Planning and Development Services Division Vote Report

Petition: **P.Z. 07-2016 Willows at Brookings Park (Amendment to CUP #31)**: A request to amend Conditional Use Permit (CUP) #31 to amend the development conditions in an “R-1” Residence District, “R-3” Residence District, and “FPR1” Flood Plain Residence District for a 26.65 acre tract of land located southwest of the intersection of South Woods Mill Road and Brookings Park Drive. (18Q140361, 18Q140370, 18Q140352, 18Q140077).

Re: PZ 07-2016 Willows at Brooking Park (Amendment to CUP#31) REVISED

TSD-2.0

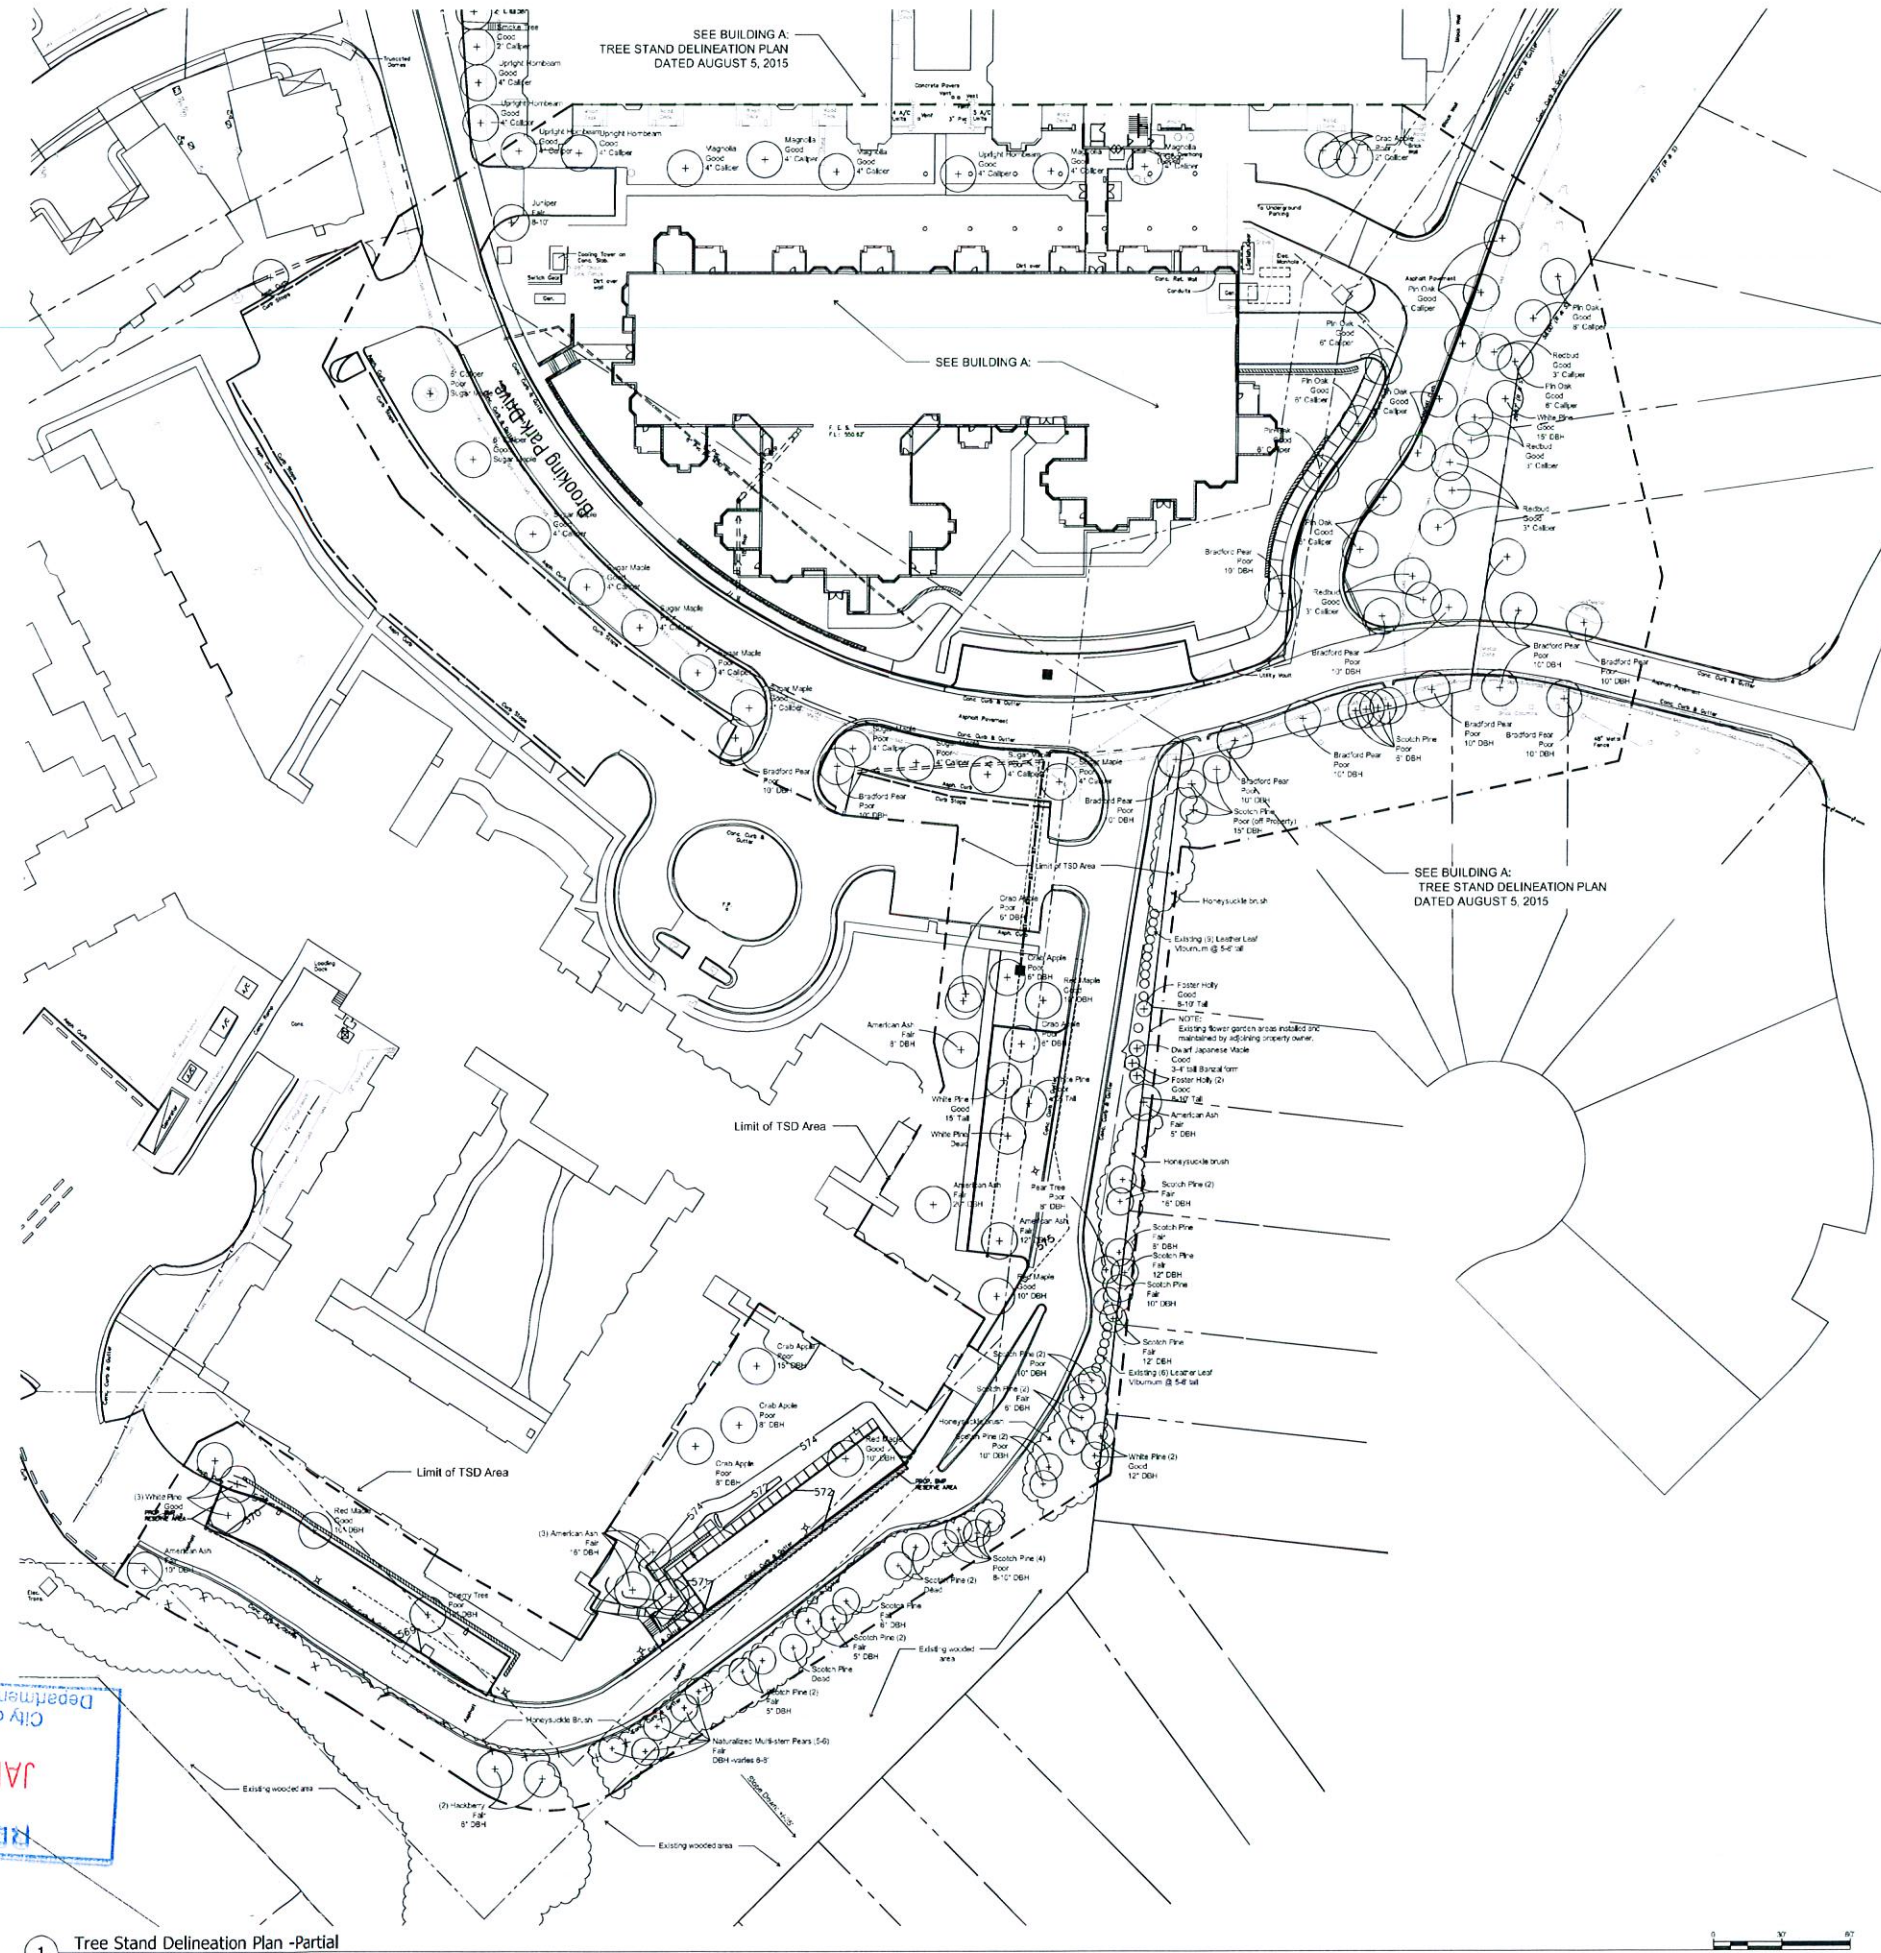
4. *Clarify which trees are to be removed by showing the proposed parking areas on the TSD.*

Comment 4: Clarify which trees are to be removed by showing the proposed parking areas on the TSD.

The applicant added the proposed parking areas to the TSD to show which trees would be impacted. Additionally, the proposed parking has been modified to save the maple tree which was of specific concern.

Response 4: The Tree Stand Delineation Plan “TSD-2.0” has been modified to reflect the addition of the proposed parking stalls and the impact on the existing trees. The number of proposed stalls was reduced at the southeast corner of Brooking Park to save the Maple Tree per the agreement with the Terraces at Woods Mill.
